BAR 21-09-01
209 2nd Street, SW, Tax Parcel 280077000
Downtown ADC District
Owner: Same Street LLC
Applicant: Jim Rounsevell
Project: Alterations to existing structure

**CITY OF CHARLOTTESVILLE
BOARD OF ARCHITECTURAL REVIEW
STAFF REPORT
September 21, 2021**

BAR 21-09-01

209 2nd Street, SW, Tax Parcel 280077000

2 RIGHT SIDE ELEVATION

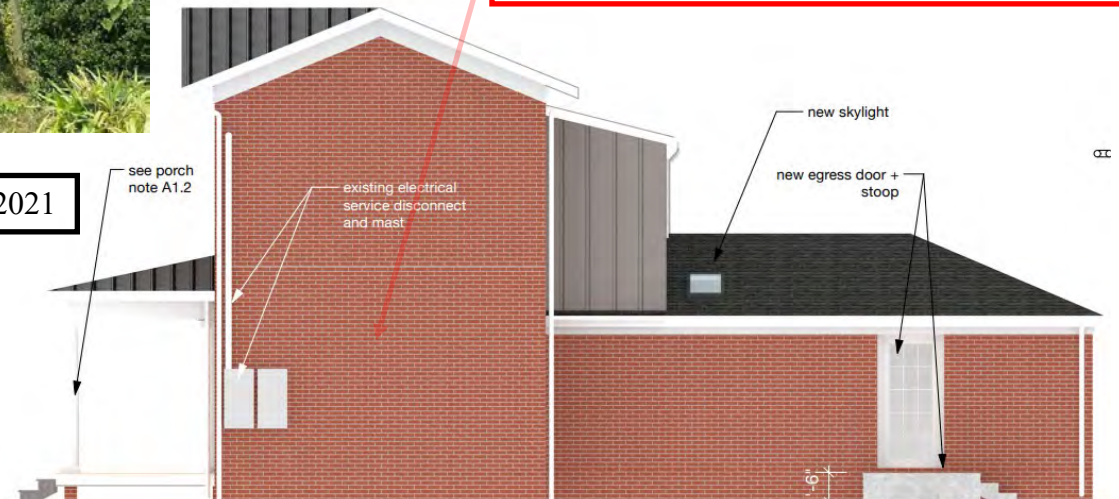
Staff note (9/2021): This window has already been removed. See staff report for discussion.

EXISTING REAR ELEVATION

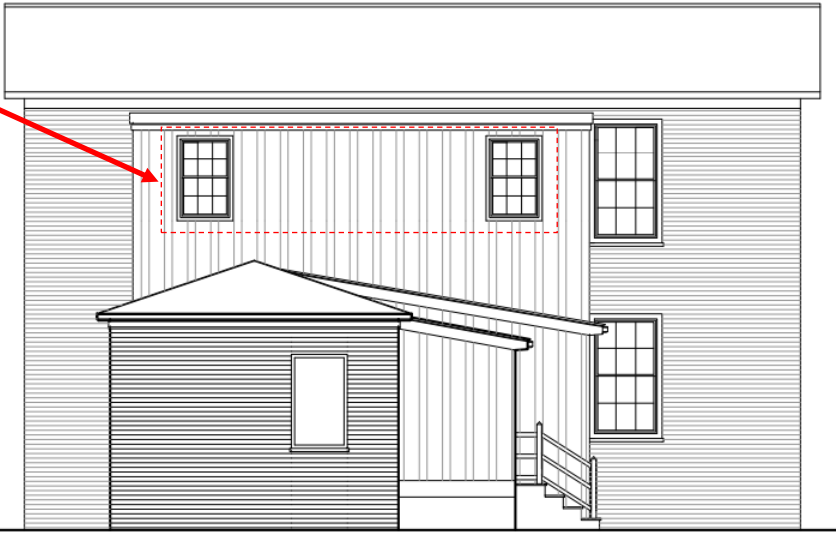
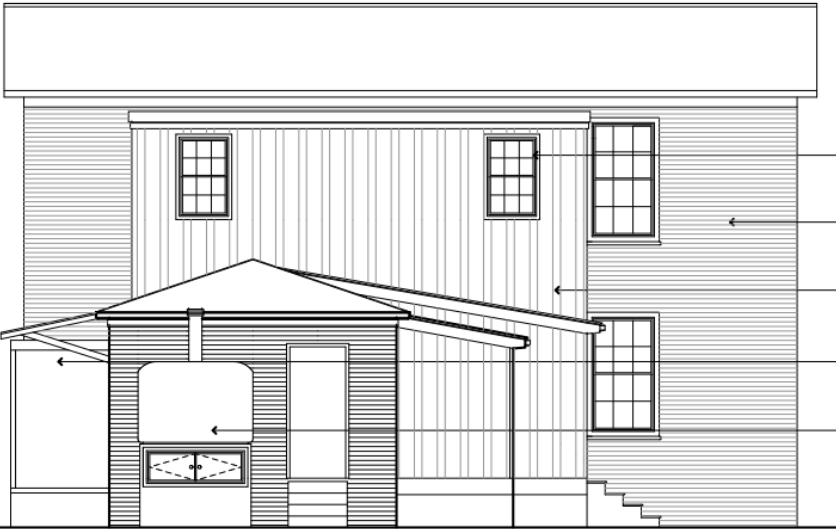
Staff note (9/2021): Windows shown incorrectly. Existing are single sash. (see below.)

See window note above. New windows to be 6-lite casement.
